PRE-APPLICATION MEETING NOTES

Randy Brown Industrial buildings
PA20-50

Thursday, December 3, 2020 – Revised January 7, 2021

Description: The applicant is proposing the construction of 4 industrial buildings for warehouse distribution totaling 1,185,075 square feet.

Six Year Street Priorities

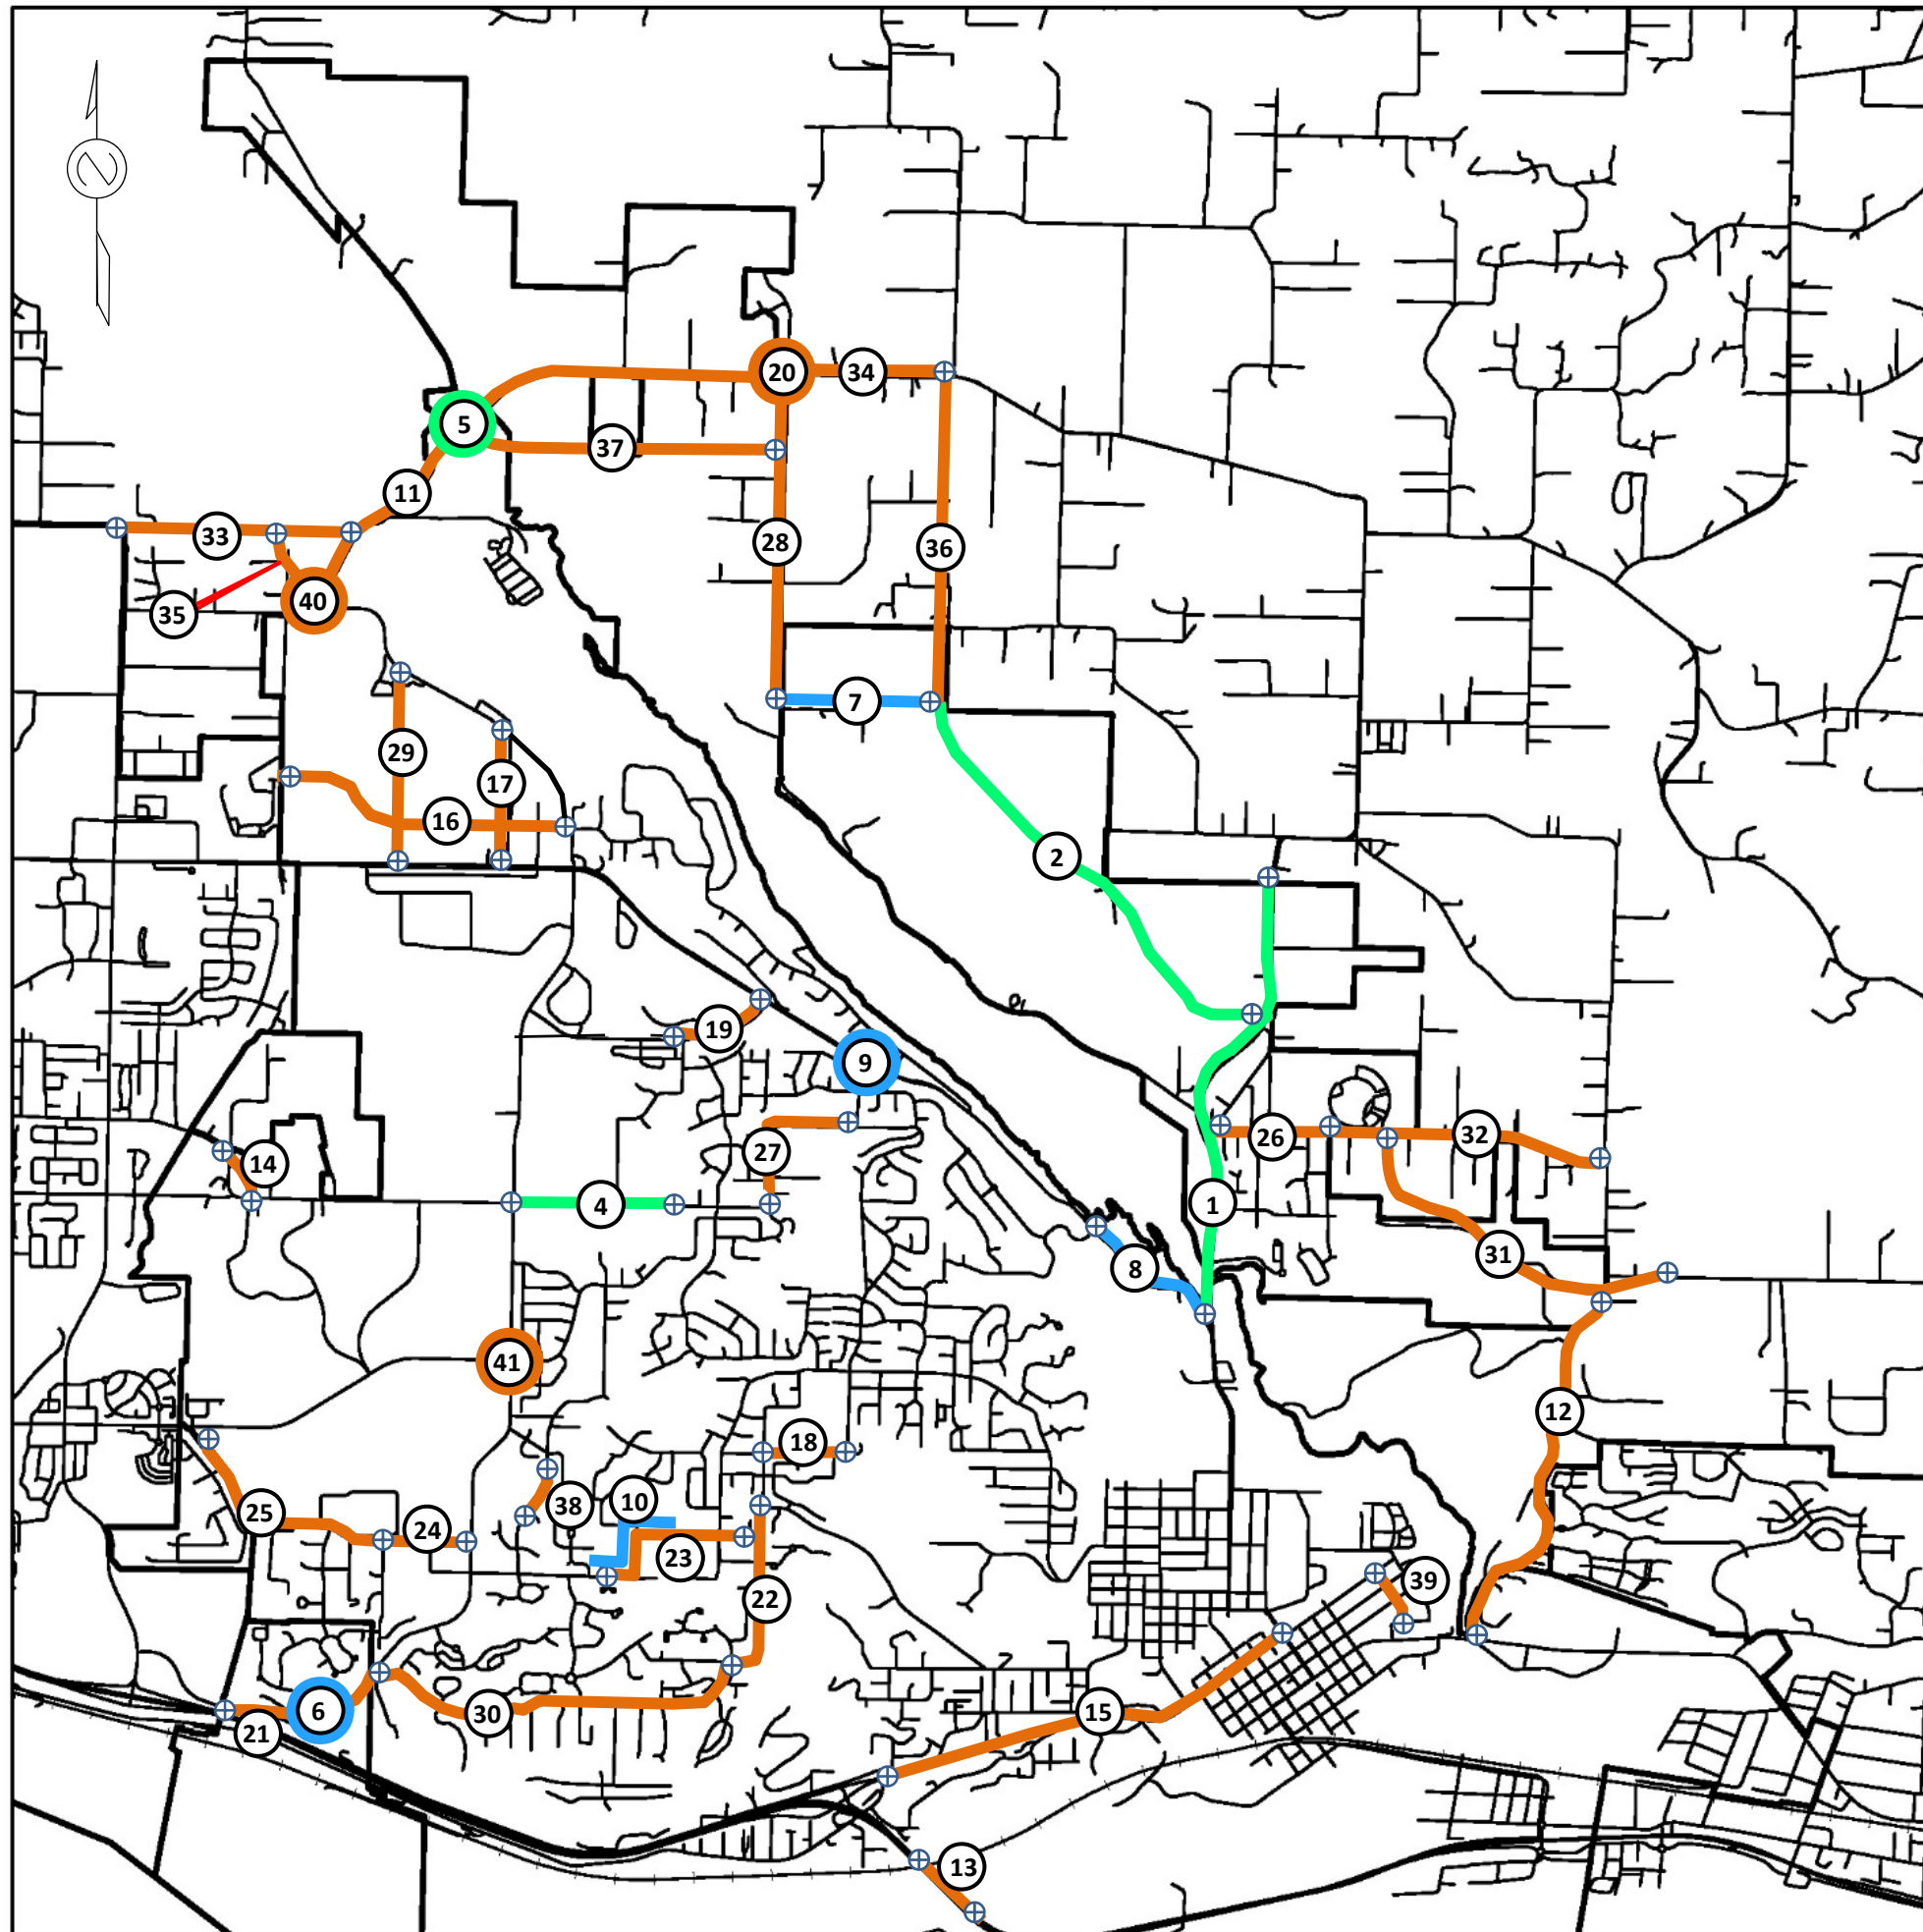
11. Future Street "A" and Street "B", as shown in the 6-year Transportation Comprehensive Plan, are over and across the proposed development. See attached 6-year street plan and exhibits.
